Access Compliance Report Public Rights-of-Way (Curb Ramps)

Main Street: **MERCANTILE_WAY** Cross Street: **SECOND_ST** Location: **NE**

ADA ID: **RPRK211029124718** Ramp Type: **Type 4 - Parallel** Initial Pass/Fail: **Fail** Overall Compliance: **No** Severity Score: **16**

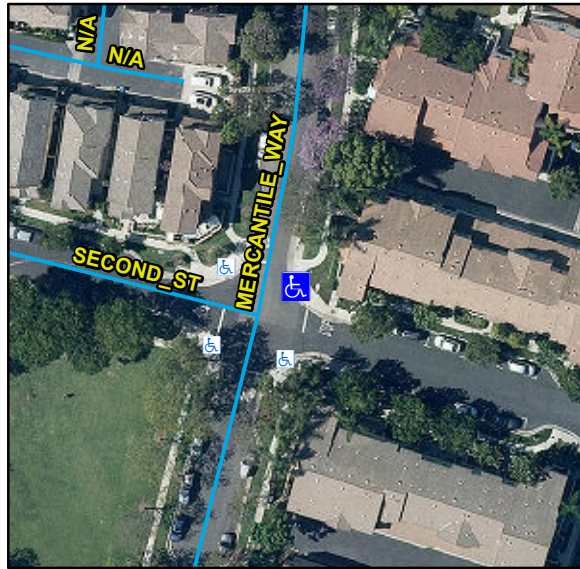
Compliance	Description	Data	Compliance	Description	Data
N/A	Ramp Length LT (in)	99	N/A	Ramp Length RT (in)	99
Yes	Ramp Width LT (in)	90	Yes	Ramp Width RT (in)	90
No	Ramp Run Slope LT (%)	9.4	Yes	Ramp Run Slope RT (%)	1.2
No	Ramp Cross Slope LT (%)	4.8	No	Ramp Cross Slope RT (%)	2.1
N/A	Landing Present	N/A	N/A	DWS Provided	N/A
N/A	Landing Length (in)	N/A	N/A	DWS Contrast	N/A
N/A	Landing Width (in)	N/A	N/A	DWS Length (in)	N/A
N/A	Landing Run Slope (%)	N/A	N/A	DWS Full Width	N/A
N/A	Landing Cross Slope (%)	N/A		DWS Offset Type	N/A
N/A	Landing Movement Obstructed?	N/A	N/A	DWS Offset Left (in)	N/A
	Landing Movement Type	N/A	N/A	DWS Offset Right (in)	N/A
N/A	Landing Shared	N/A			
N/A	Clear Space	Yes			
N/A	Clear Space To Crosswalk (in)	N/A			
N/A	Marked Crosswalk 1	No	N/A	Marked Crosswalk 2	No
	Crossing 1 Direction	NW		Crossing 2 Direction	SW
	Marked Crosswalk 1 Width (in)	N/A		Marked Crosswalk 2 Width (in)	N/A

Remove & Replace Curb Ramp With Two New Directional Ramps or Equivalent.
